Planning Commission Staff Report

SUBJECT: DR22-164 MELODY AVE BUILDING 1 & 2

Approve the Findings of Fact and approved DR22-164 MELODY AVE BUILDINGS 1 & 2: Site plan, landscaping, grading and drainage, elevations, floor plans, lighting, and colors and materials for approximately 3.1 acres, generally located at the southwest corner of Horne St. and Melody Ave., and zoned Light Industrial with a Planned Area Development (PAD) overlay.

GILBERT MELODY BDLG 1 - GRADING & DRAINAGE PLAN

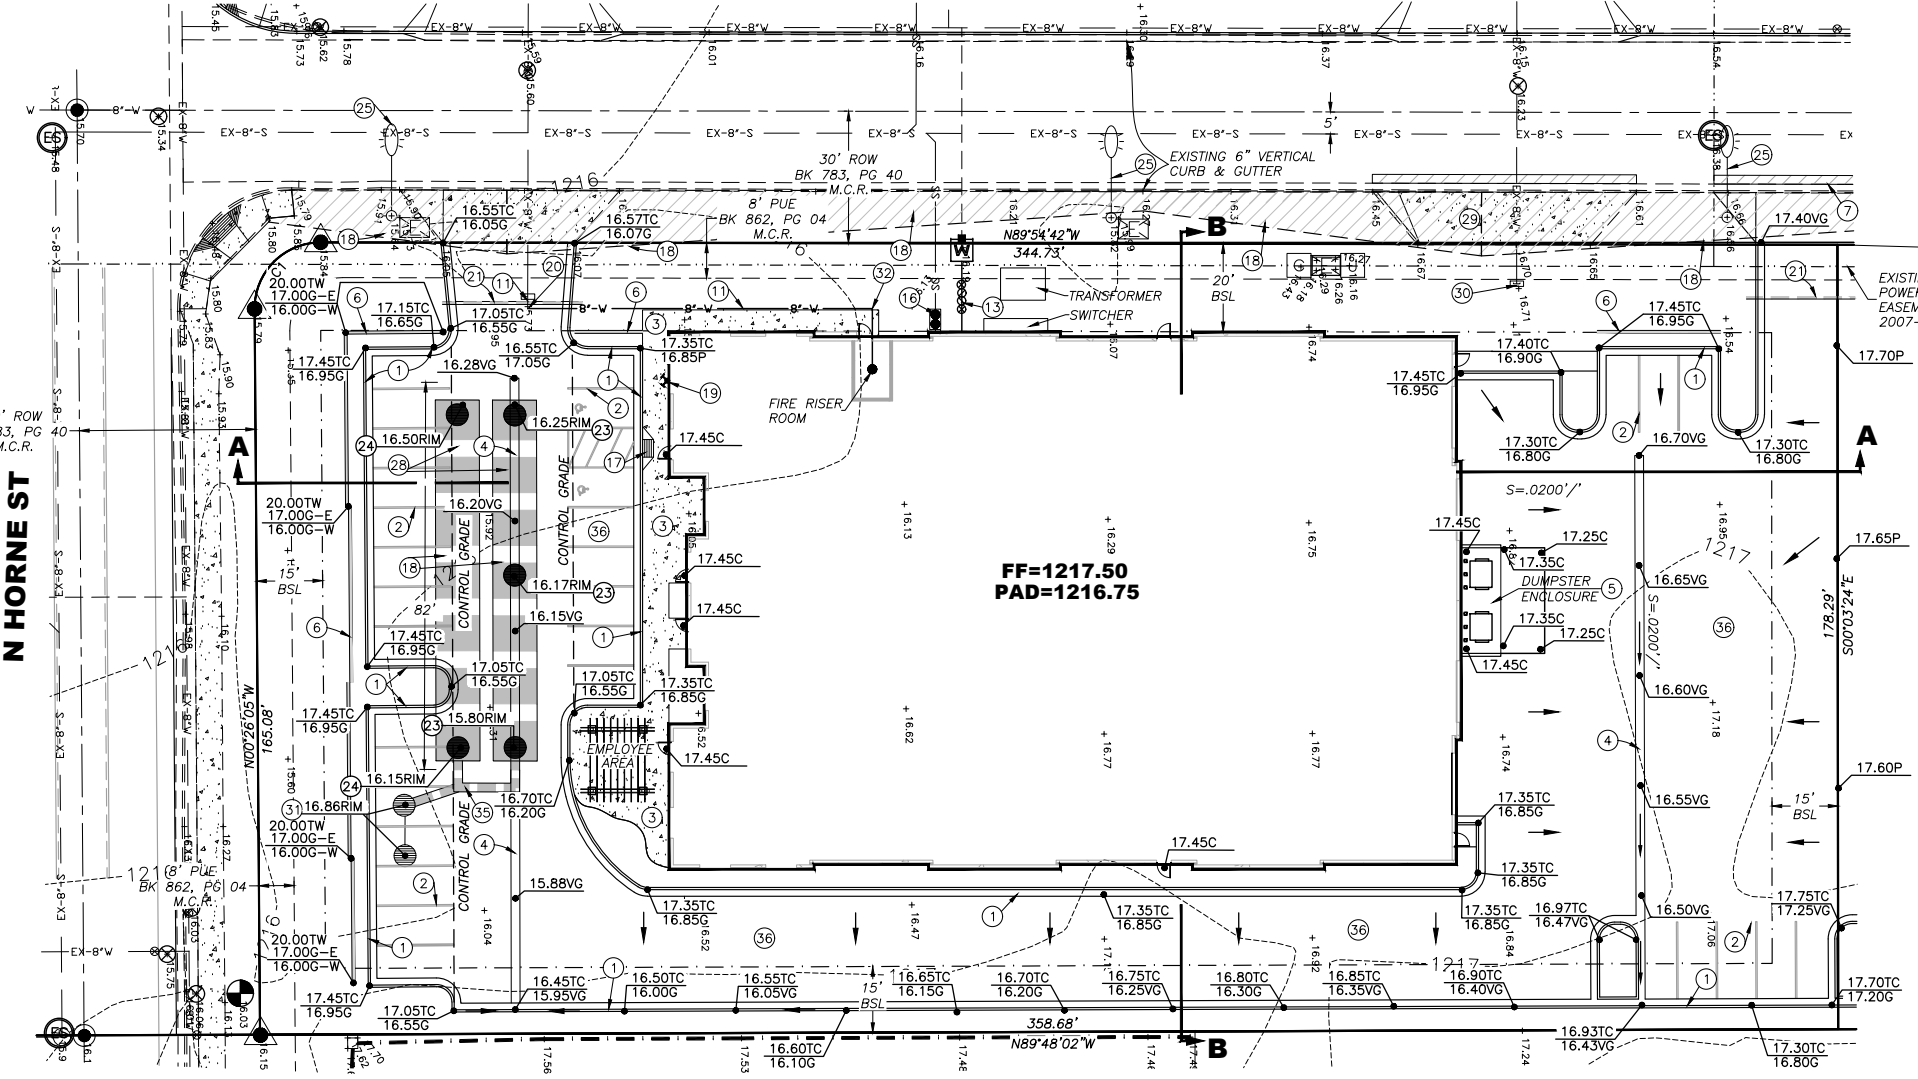
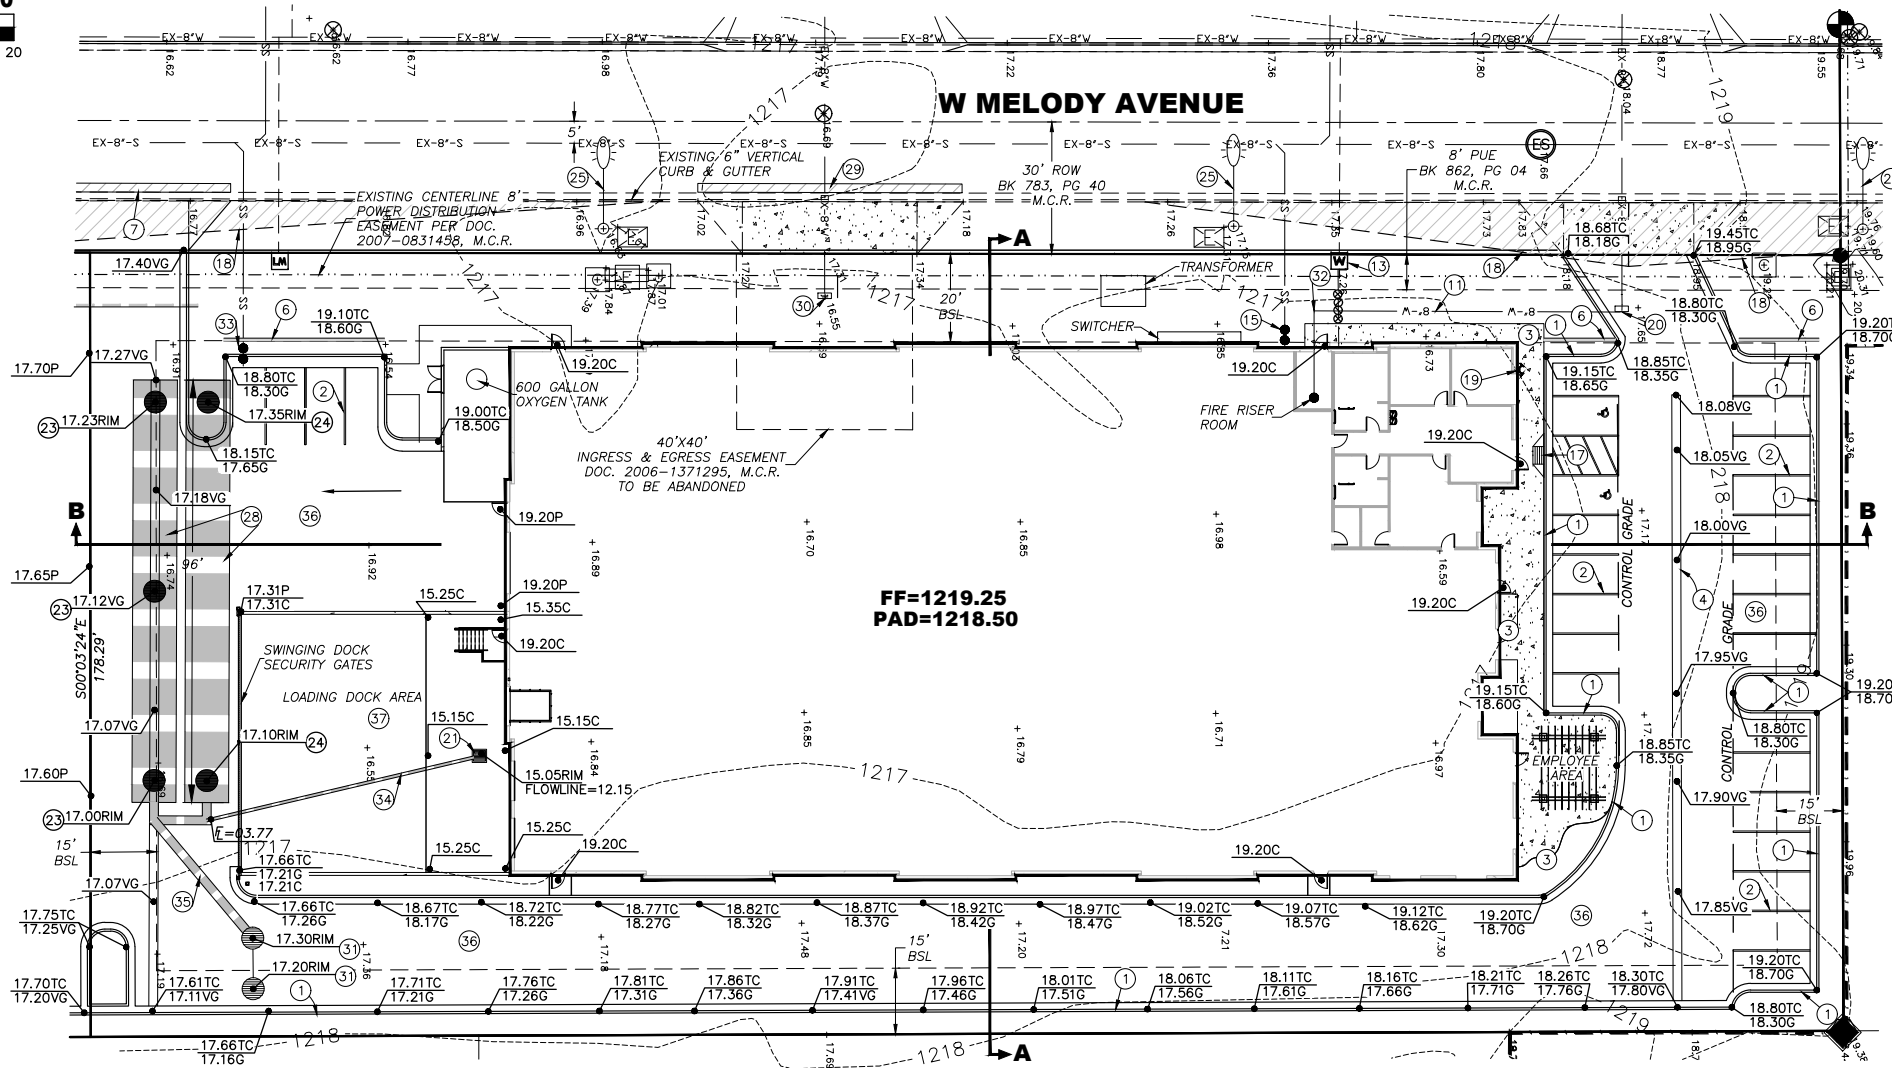
- Commissioner Fay stated that he is not against regional retention basins, but the problem is that no retention analysis has been done. He also questioned whether the retention basins were owned by someone outside of the HOA. If this is the case, then Commissioner Fay would be against the CDs at risk. Normally a CDs at risk would be issued liberally, but in this case proceeding with caution is recommended until the issue is clarified.

- Due to uncertainty over the ownership of the existing regional retention basin along the northern boundary of the Fuller Industrial Park the applicant is proposing to retain all developed storm water flows in underground retention tanks located in the western parking lot and the loading dock area between the two buildings.

NORTH ELEVATION

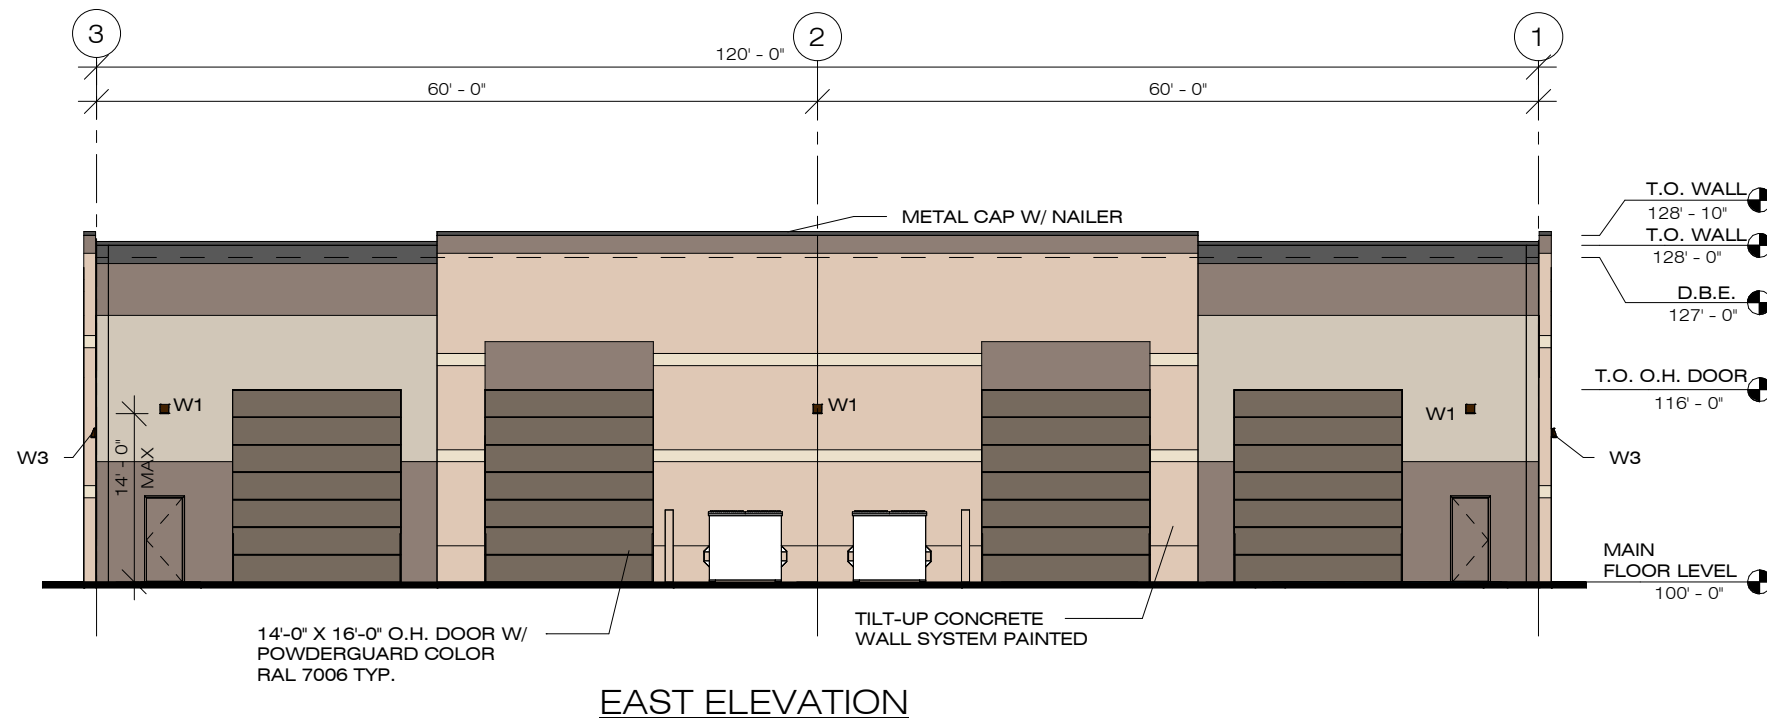
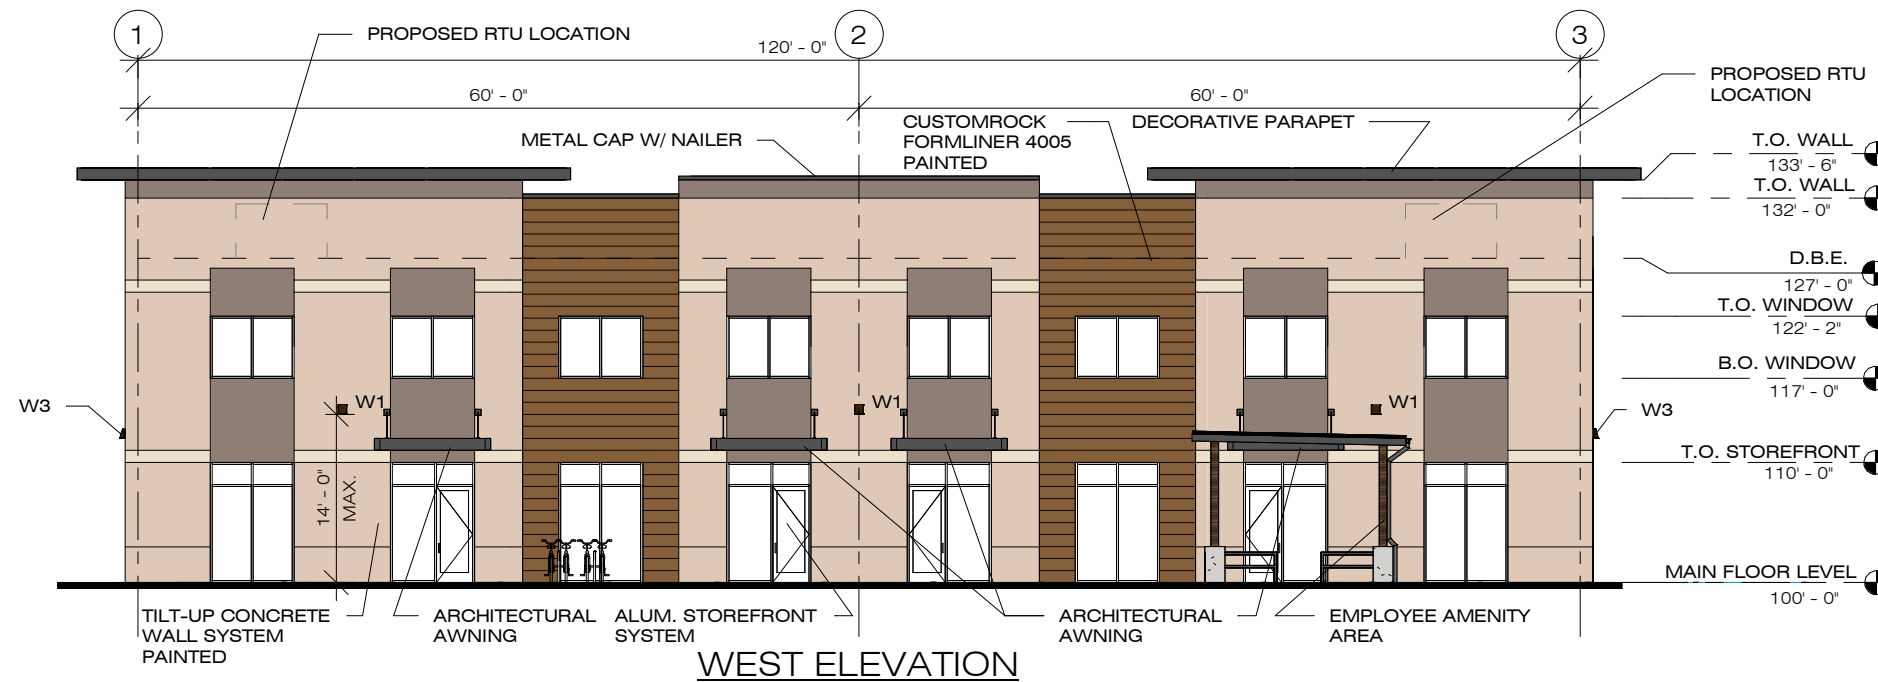
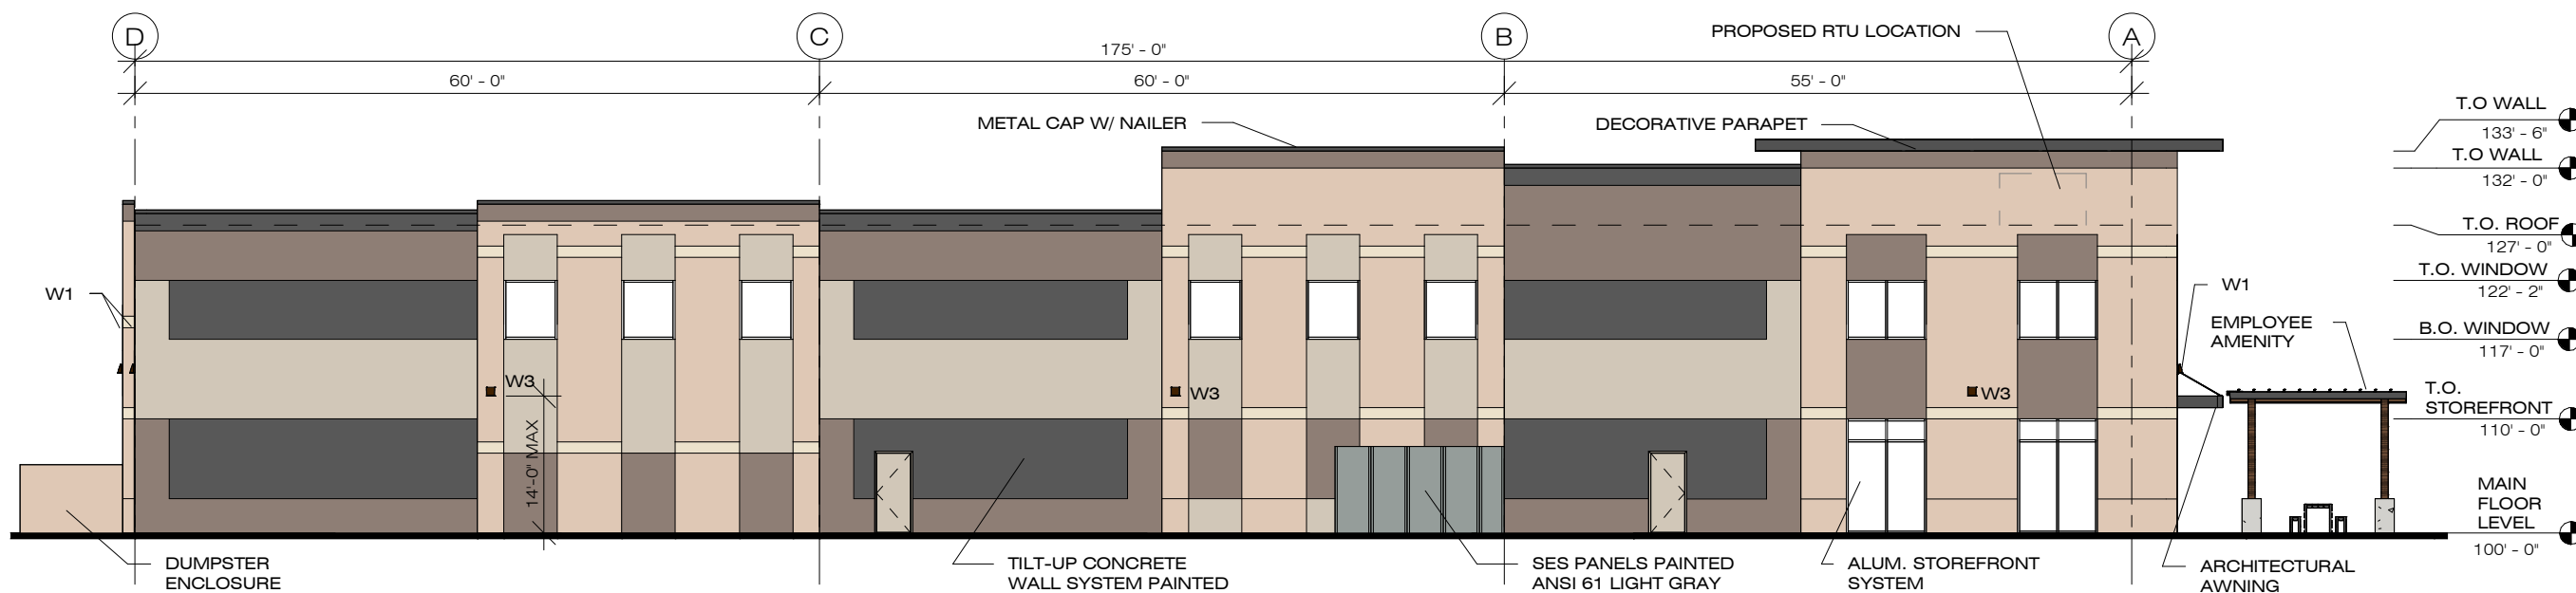
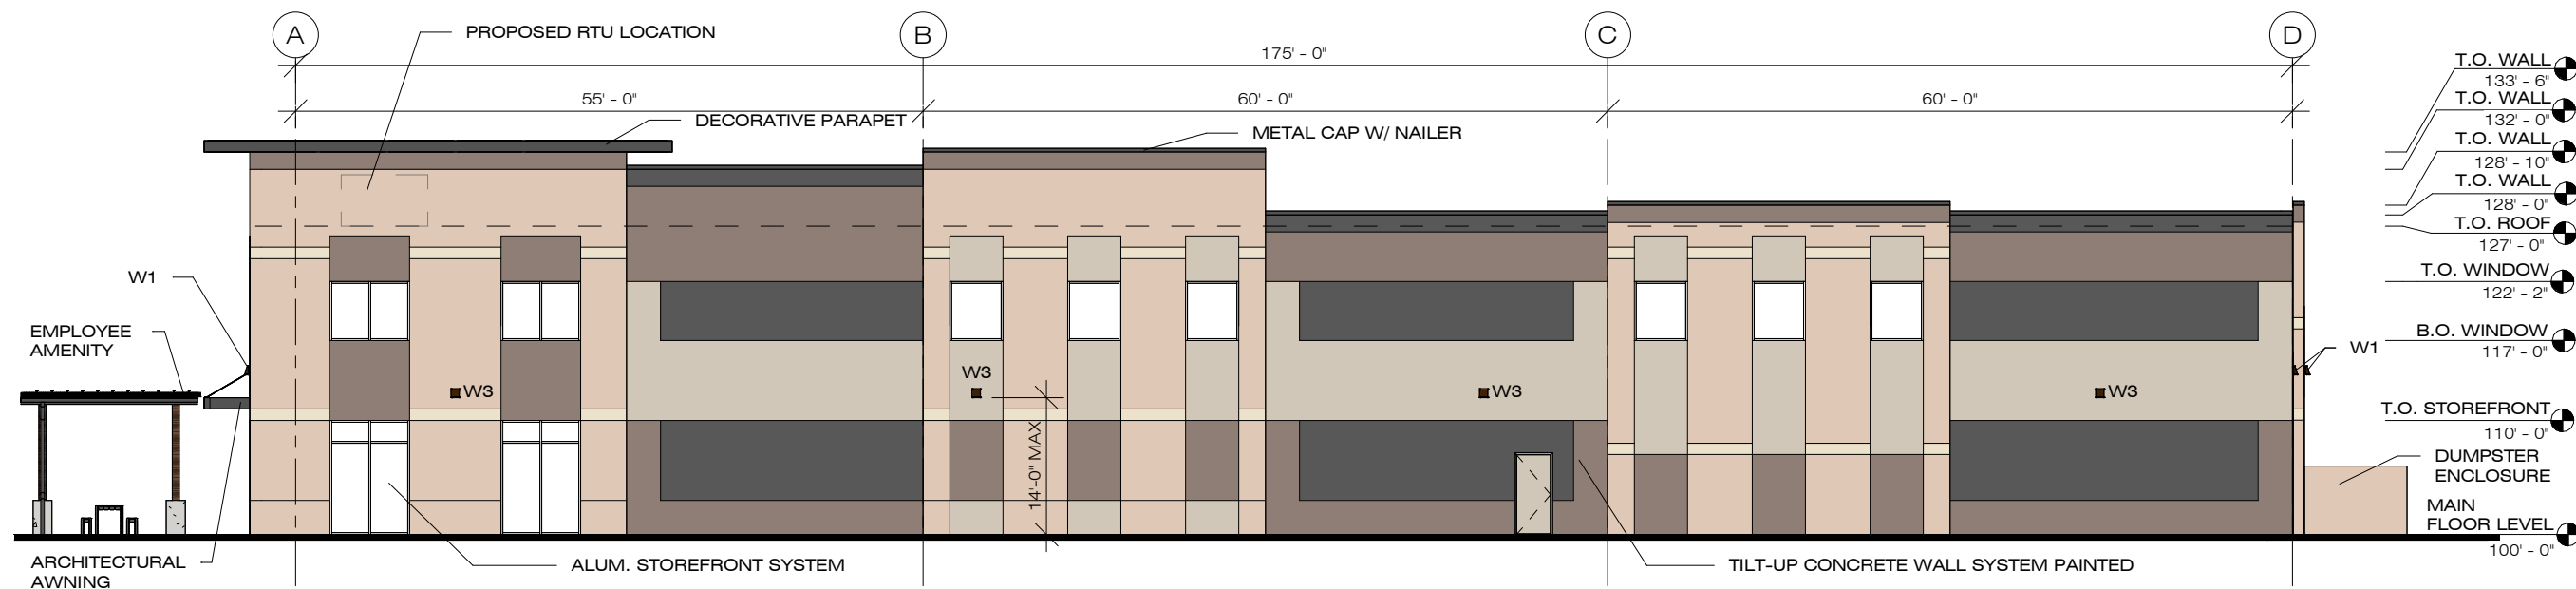
- Commissioner Davis agreed that the north elevation could use additional articulation. She suggested better defining the entrances and providing additional weather protection by adding canopies over each entrance.

- Commissioner Bianchi stated that his main concern was the deficient parking and agreed with Commissioner Davis regarding the entrances and articulation.
